AIRPORT LAND USE COMMISSION RIVERSIDE COUNTY AGENDA

Thursday 9:00 A.M., March 12, 2015

- 2.1 ZAP1107MA14 – Proficiency 215 LLC/Proficiency Capital LLC/Jeff Trenton (Representative: Pam Steele, MIG/Hogle-Ireland) – March Joint Powers Authority (JPA) Case Nos. GPA 15-01 (General Plan Amendment), CZ 14-01 (Change of Zone) and PP 14-02 (Plot Plan). A proposal to establish Industrial zoning on 39.42 acres (Assessor's Parcel Nos. 297-100-013 and 297-100-045) located southerly of Alessandro Boulevard, easterly of Interstate 215, westerly of Old 215 Frontage Road, and northerly of Cactus Avenue, and to build a 709,083 square foot industrial warehouse (including 15,000 square feet of office area, 3,000 square feet of which will be on a mezzanine level) thereon. The easterly 6.2 acres (Assessor's Parcel No. 297-100-045) was zoned R-R (Rural Residential) when in County jurisdiction. GPA 15-01 is a proposal to designate the easterly 6.2 acres of the site (Assessor's Parcel No. 297-100-045) as Industrial on the March JPA General Plan. (Airport Compatibility Zones B1-APZ I and B1-APZ II of the March Air Reserve Base/Inland Port Airport Land Use Compatibility Plan). Continued from February 5, 2

**General Plan Amendment for APN 297-100-045
Freeway Business Center
Proficiency 215 LLC**

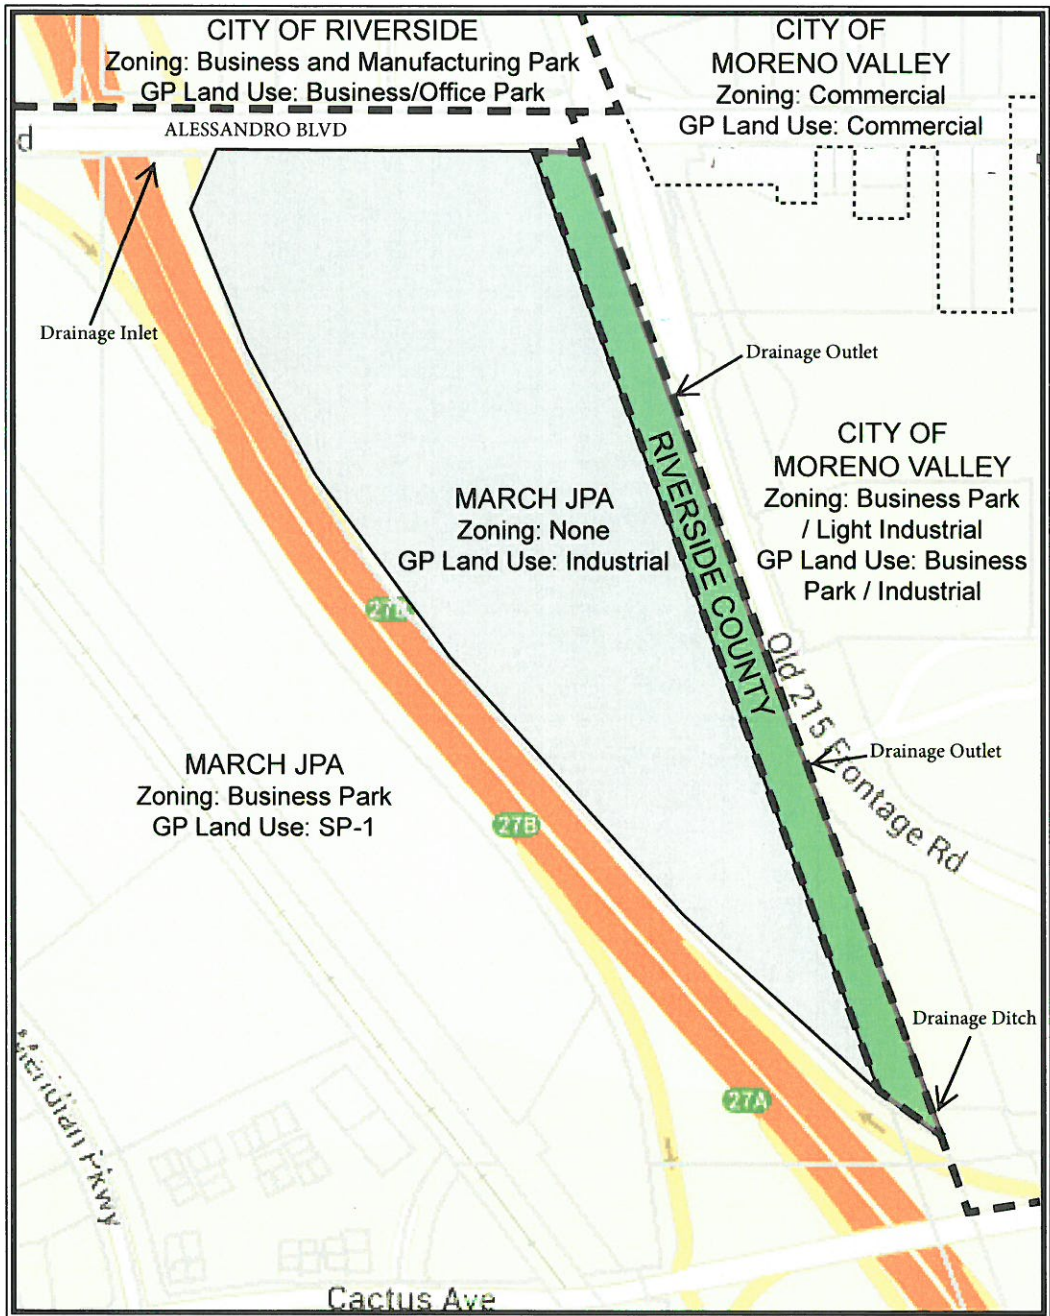
This application can be supported as noted below:

1. The proposed Land Use designation is Industrial, which is consistent with the March JPA General Plan Land Use designation for the area. The larger contiguous 33.2 parcel already is located within the Industrial Land Use of March JPA's General Plan. The attached Comprehensive Evaluation of General Plan Goals and Policies discusses the project's compatibility with March JPA's General Plan.
2. The smaller 6.2 acre parcel had a County zoning designation of RR (Rural Residential) and did not have a Riverside County General Plan Land Use designation.
3. The project location is compatible with surrounding industrial uses. Robertson's Ready Mix, a concrete manufacturer, is located directly

4. The proposed project site is currently vacant. There is adequate infrastructure to serve the development.
5. A Zone Change application has been submitted to establish the Industrial zone on the project site.
6. No changes are required to the comprehensive list of the goals, objectives, policies, programs and text changes of the General Plan. The change will occur in the zoning and land use maps to designate the smaller parcel as Industrial.

SITE PLAN

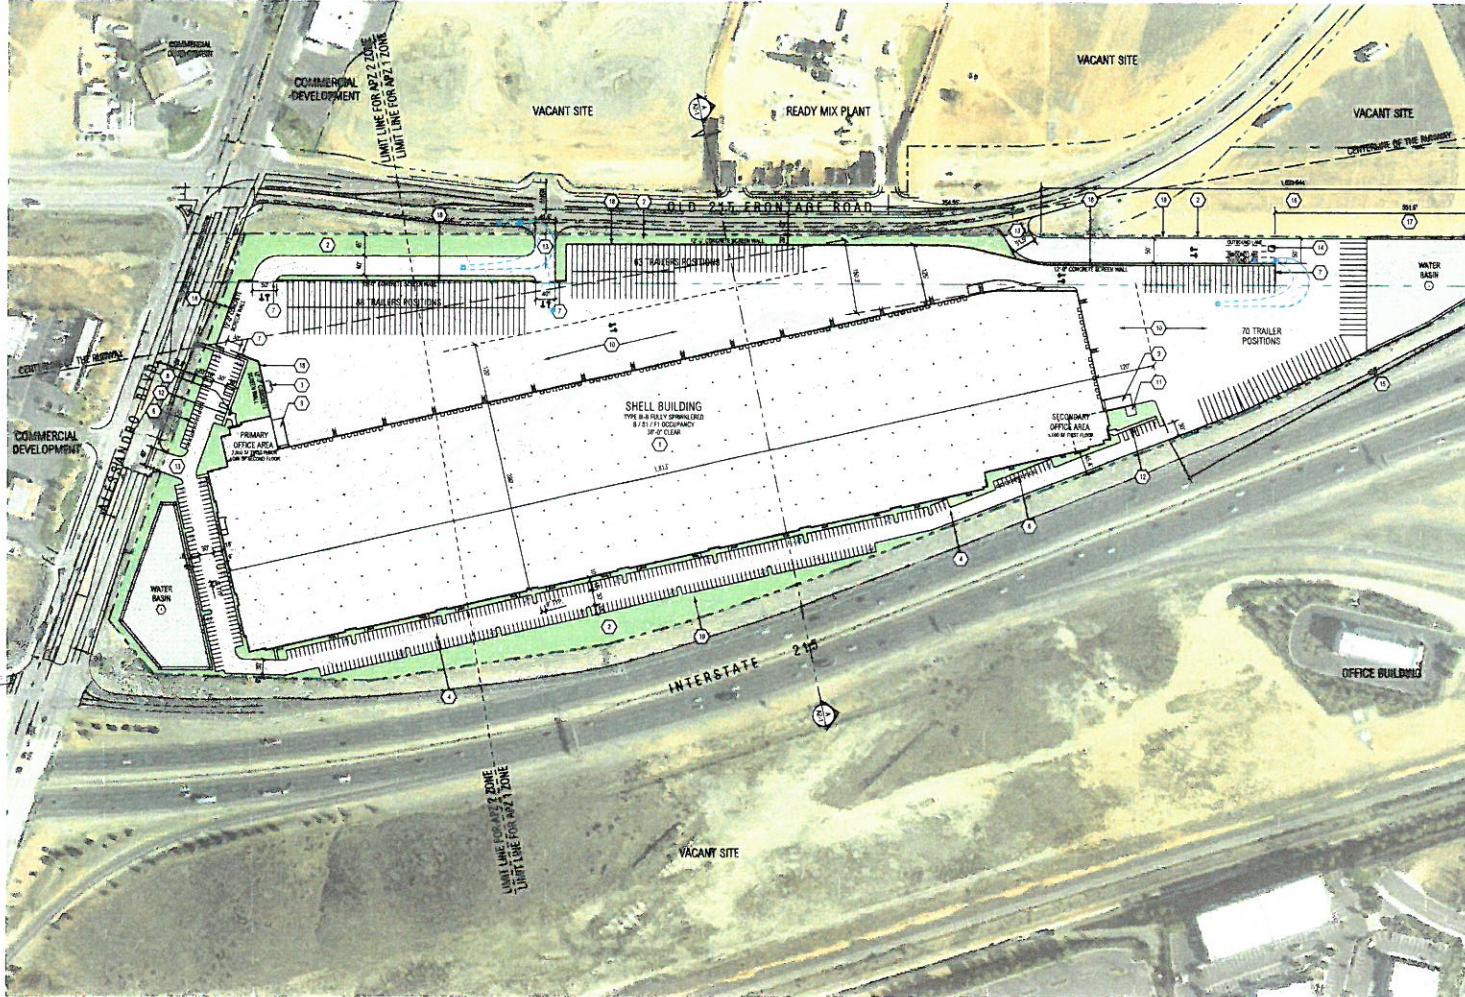
Hi John — We just received notice of this meeting, and we were finally able to obtain a copy of the proposed site plan. We own the property immediately adjacent to the south and east of the subject property. We have very limited frontage on Old 215 Frontage Road; the southerly proposed access point for the subject property appears to be at our common property line. Due to typical traffic requirements for driveway separation distances, this design will likely render our property undevelopable. Accordingly, we object to its location and the site plan, and respectfully request a change in this access design to solve this problem.
